**Re: Application for Leave to Construct – Grand Bend Wind Limited
Partnership
Board File No. EB-2013-0185**

**GRAND BEND WIND LIMITED PARTNERSHIP RESPONSES TO
BOARD STAFF INTERROGATORIES**

**CORRECTED VERSION OF THE LINE DRAWING ORIGINALLY PROVIDED AT
EXHIBIT B, TAB 2, SCHEDULE 3 OF THE APPLICATION**

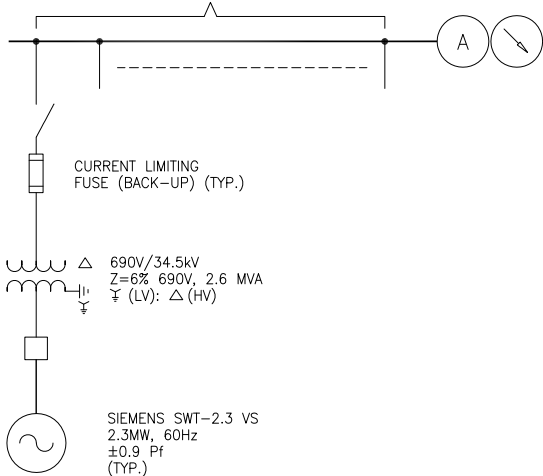
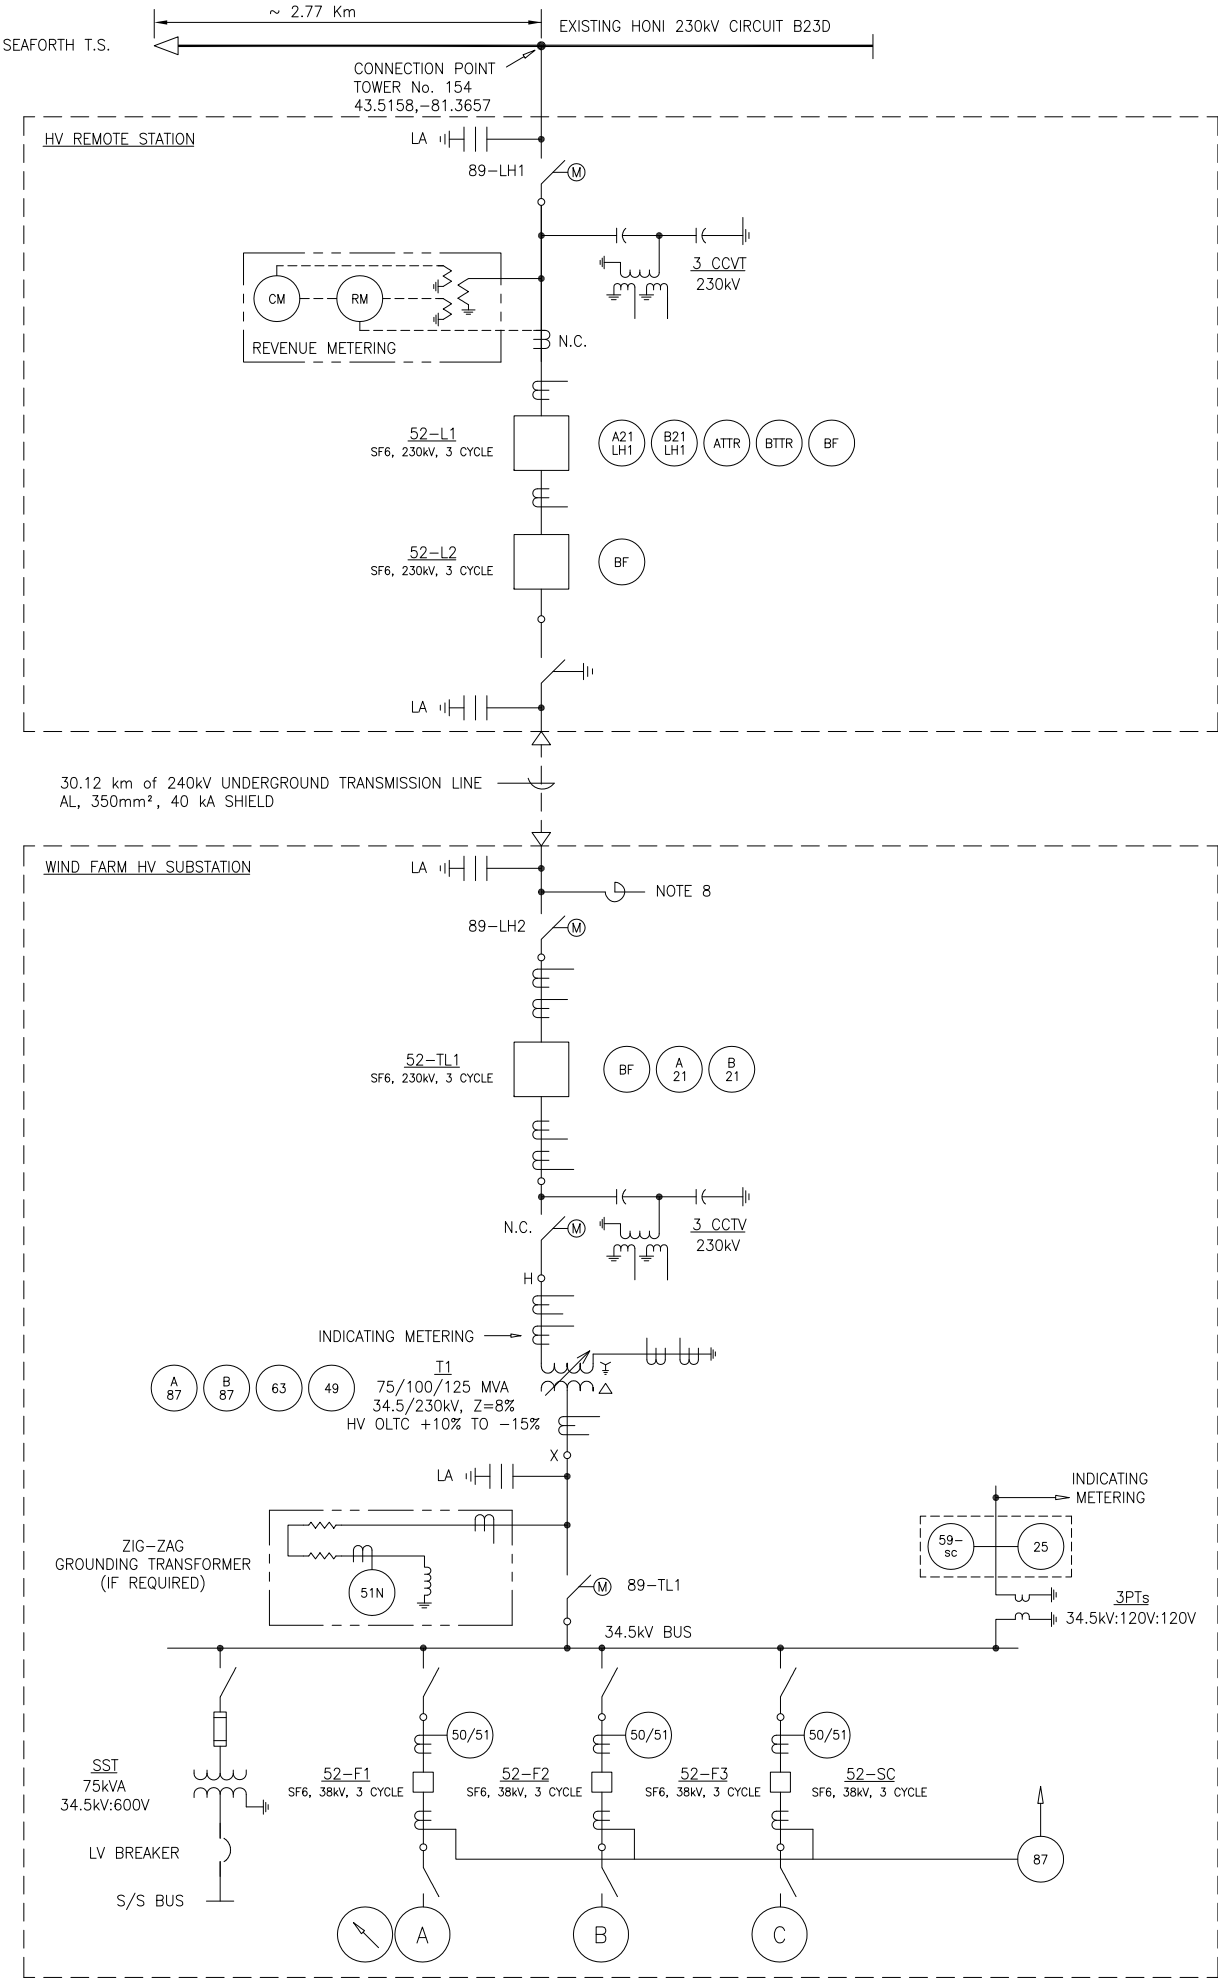
Paragraph 8 in the reference indicates that “a “step-up” transformer will be used at each wind turbine generator (“WTG”) to transform the electricity generated at the WTG 690 V to 34.5 kV....” The line drawing in Exh B, Tab 2, Sch 3 shows a total of 3 step-up transformers, each connecting a group of 14-17 turbines.

- (a) Please confirm/clarify whether there is one step-up transformer per turbine or a total of 3 transformers connecting groups of turbines.

- (a) There will be one step-up transformer for each turbine. A corrected version of the Line Drawing originally provided at Exh. B, Tab 2, Sch 3 accompanies these responses as Attachment 2(a).

Figure 2: Modified Grand Bend WF Configuration

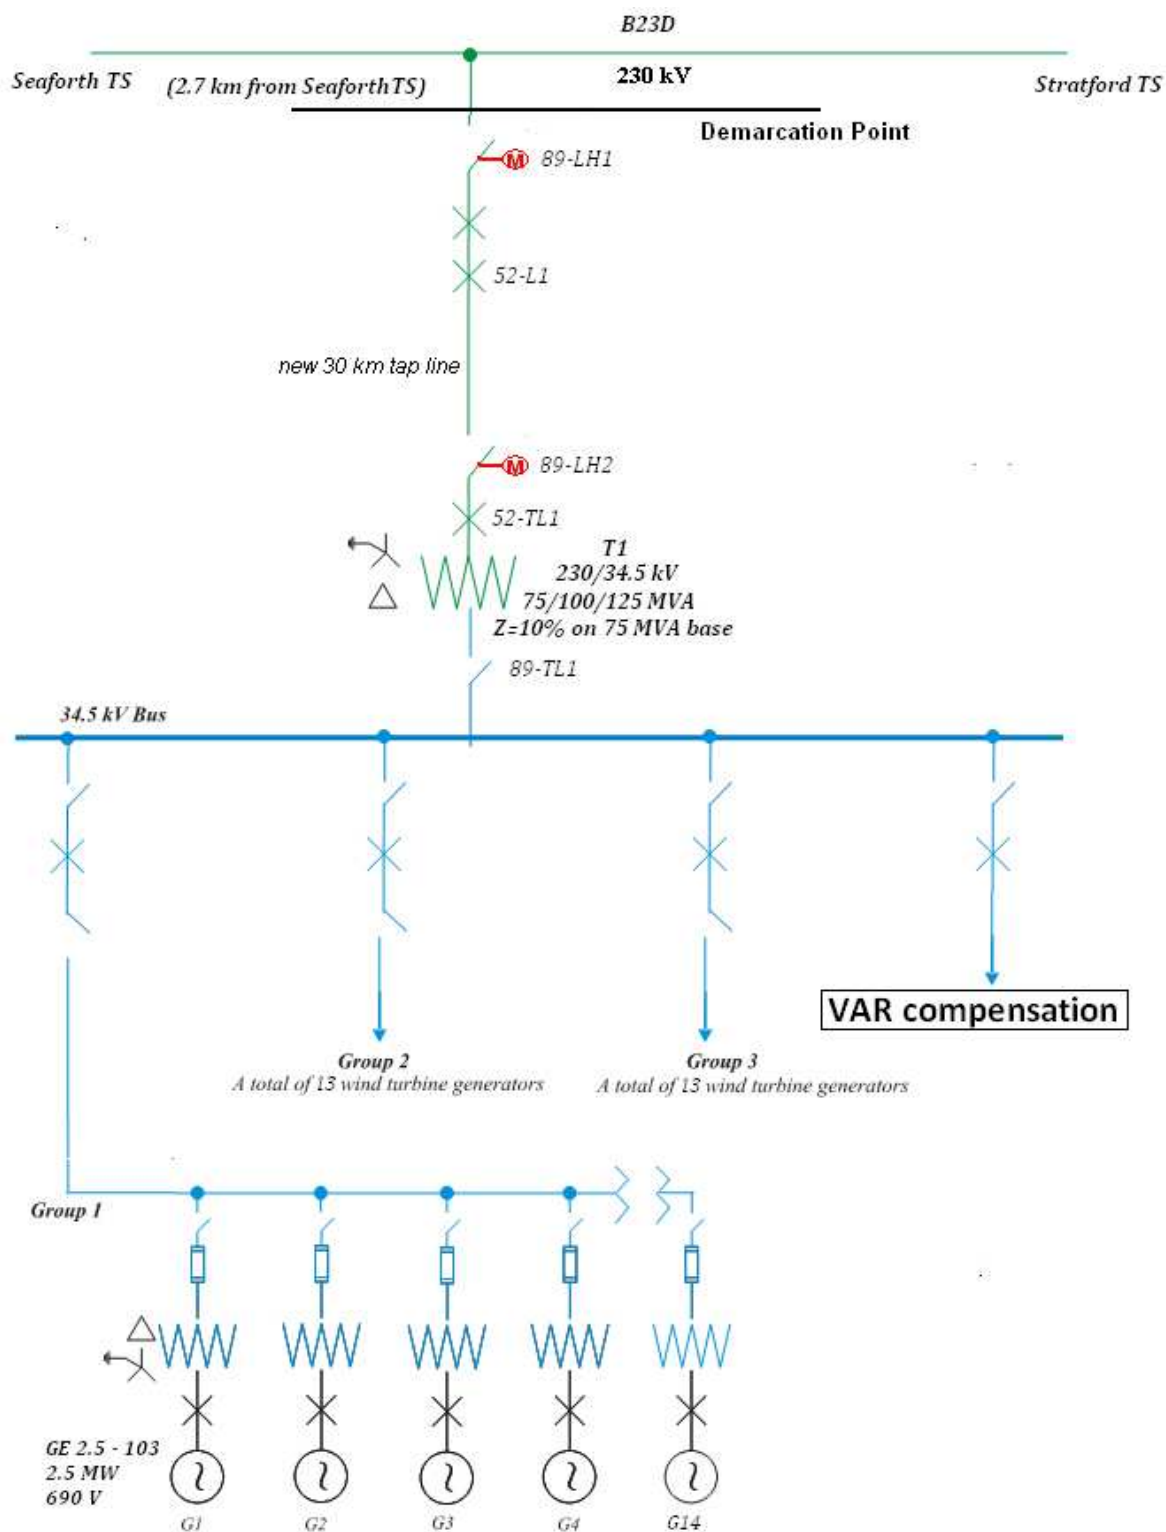
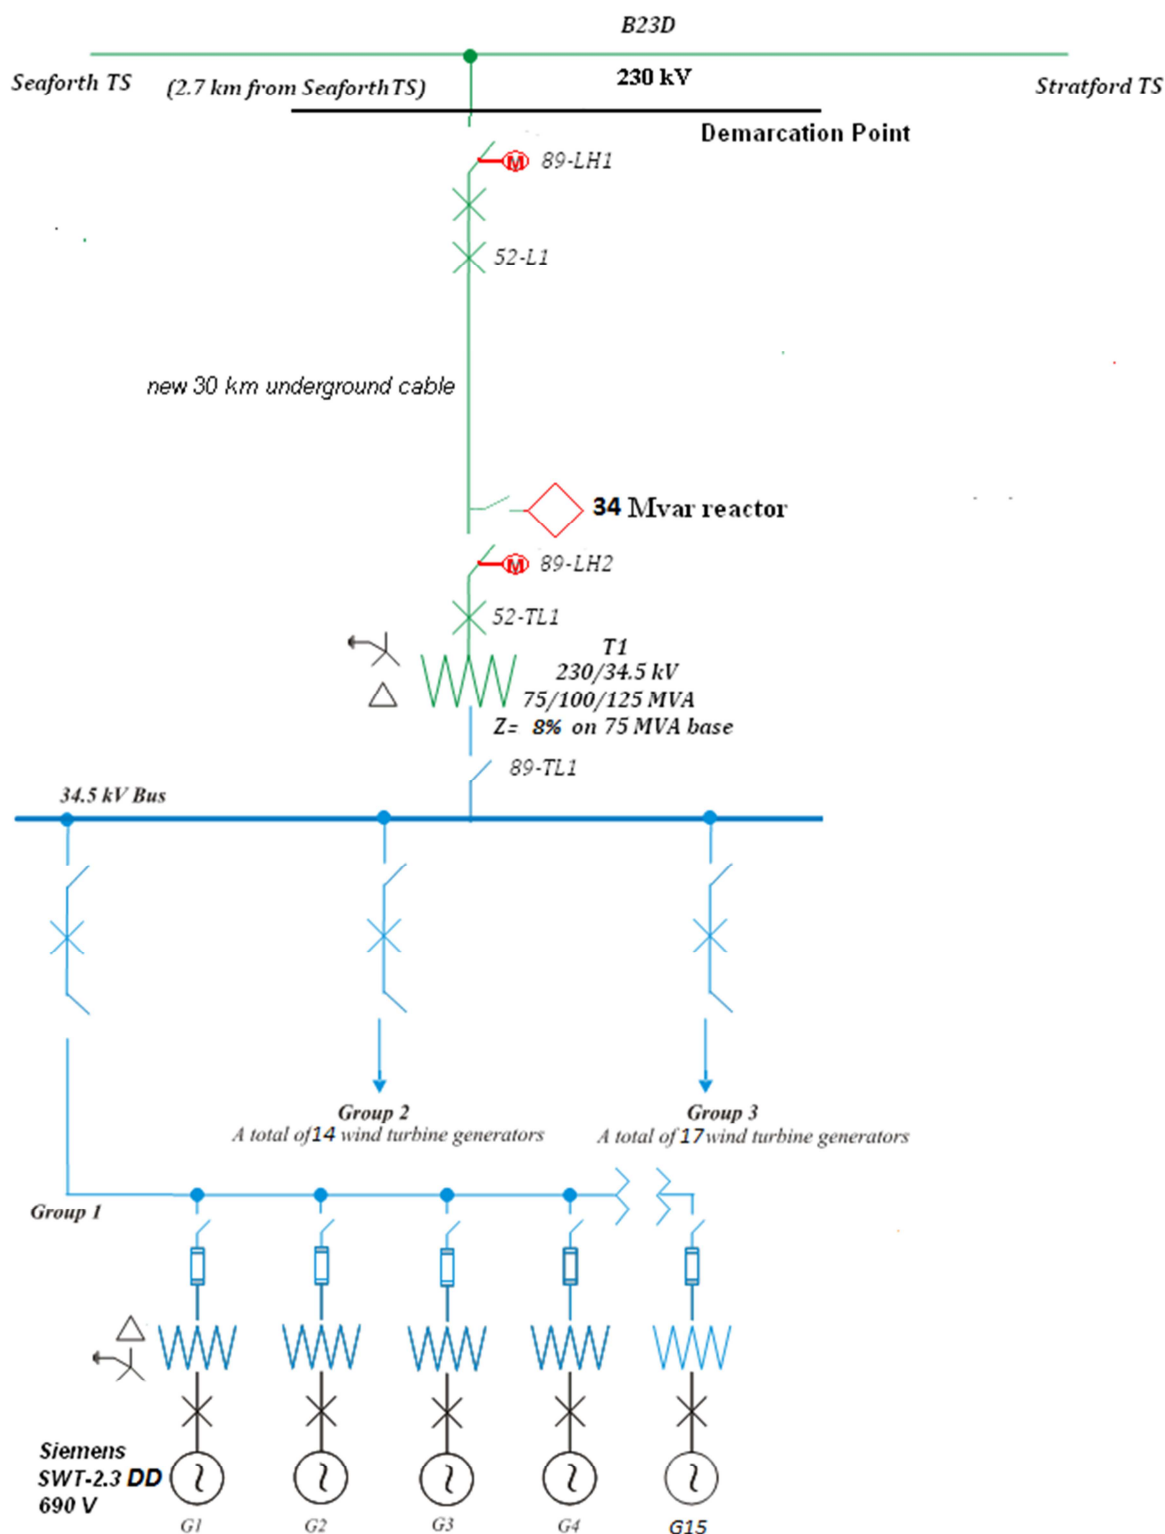
The revised configuration is shown in Figure 2, Appendix A, will not reduce the level of reliability of the integrated power system and is, therefore, acceptable to the IESO

The original configuration is shown in Figure 1, Appendix A. The following changes have been made to the original configuration:

Figure 3: Reactive power limits curves for the SWT -2.3 DD 60 Hz wind turbine at LV side of wind turbine transformer.

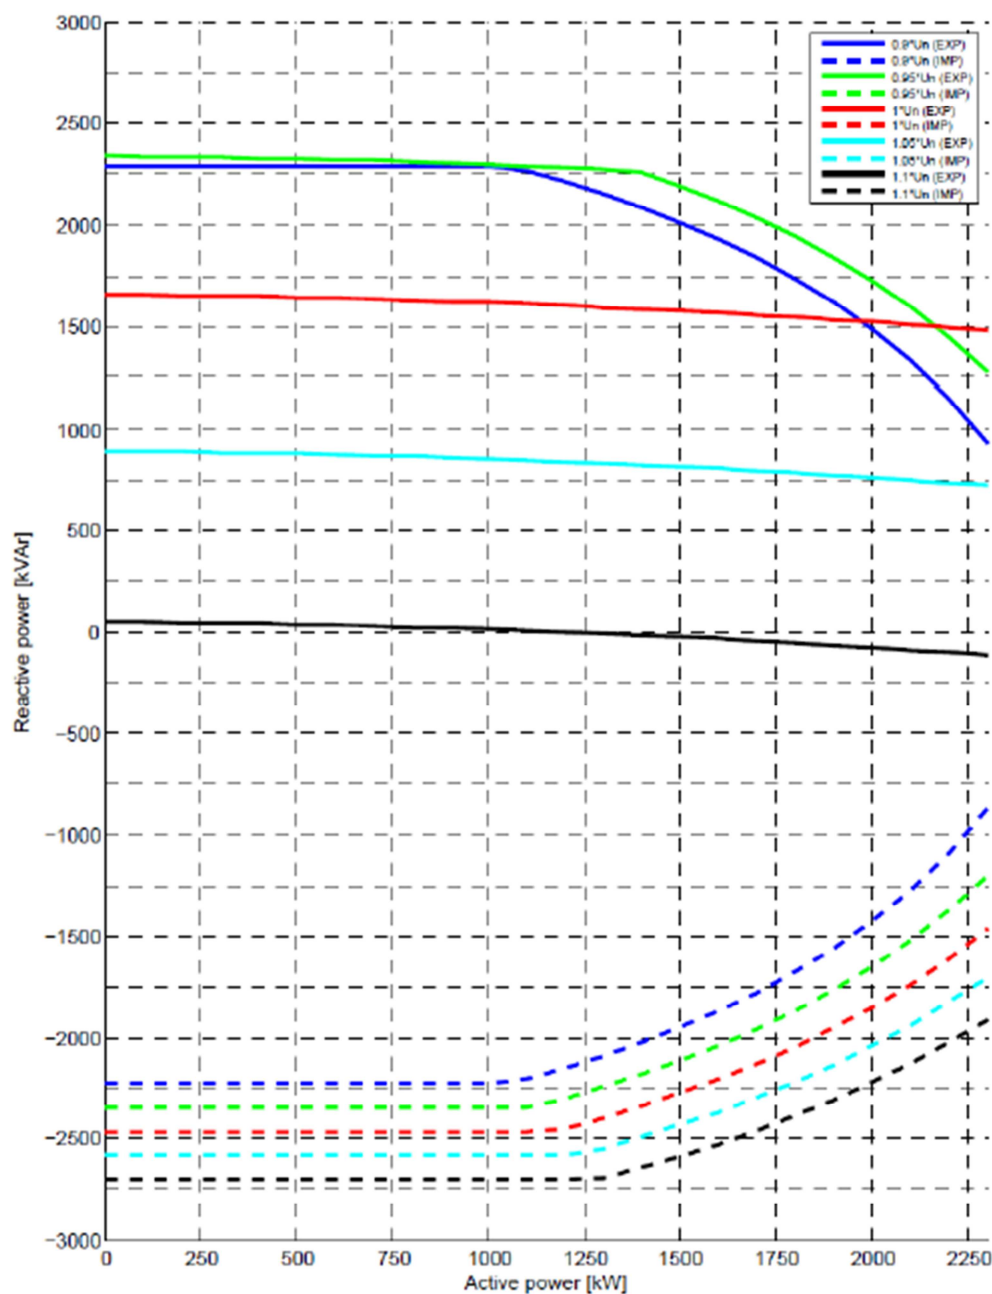
The following table summarizes the IESO's requirement for reactive power from each generator and the available capability of the Siemens SWT-2.3 DD 60 Hz wind turbine, at rated terminal voltage and rated active power. Figure 3 in Appendix A shows the reactive power capability of the generator. It is concluded that the Siemens SWT-2.3-DD WTGs can deliver the IESO required dynamic reactive power at rated terminal voltage. Thus there is no need to install an additional dynamic reactive power device.

Figure 2: Breaker positions on the line B23D (LH15 & LH19)

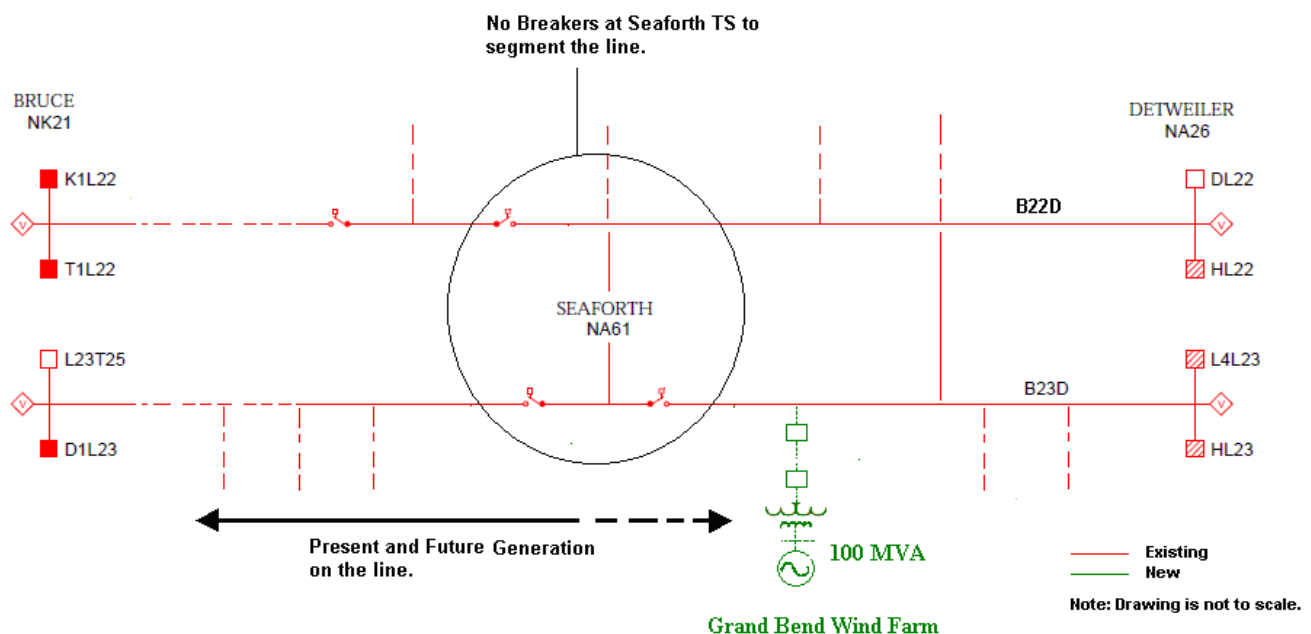
The proposed arrangement would require a breaker failure protection to be installed at the proponents HV remote station. The increased probability of faults due to an additional 30 km of 230 KV underground cable makes the region more susceptible to instabilities; an un-cleared fault (breaker failure) on this line would trip the HONI terminal stations (Bruce and Detweiler TS) resulting in a widespread tripping of the present and future customers on that line as shown in Figure 2 below – consequently degrading the reliability of the HONI circuit. The reliability is further impacted due to the procedural complexities involved and the time required for the manual restoration of the HONI circuit after a breaker failure.

The proximity of the point of connection to the Seaforth TS (2.77 km) presents a protection challenge adding to the overall impact on the reliability of the HONI circuit, this is due to the fact that existing Zone1 protection at the Seaforth TS will need to be eliminated as the reach can not be contracted enough to exclude the proponent's connection and the new WF underground cable. In addition, the capacitive effect of the 30km underground cable makes it more challenging for the breaker to interrupt the capacitive charging current.

It is therefore critical to devise an arrangement that will, to extent possible, mitigate the impact on the reliability of the HONI circuit. For this reason, it is required to have two breakers in series at the proponent's HV Remote Station to mitigate the frequent operation of a breaker failure protection – avoiding the widespread tripping as well as the difficulties involved in restoration of the line after a breaker failure.

The existing Zone1 will be eliminated at the Seaforth TS and the existing Zone 2 reach will be revised to accommodate the increased apparent impedance. The Zone 1 reach at the Detweiler TS will be reduced to exclude the proponent's connection and Zone 2 settings will be revised.
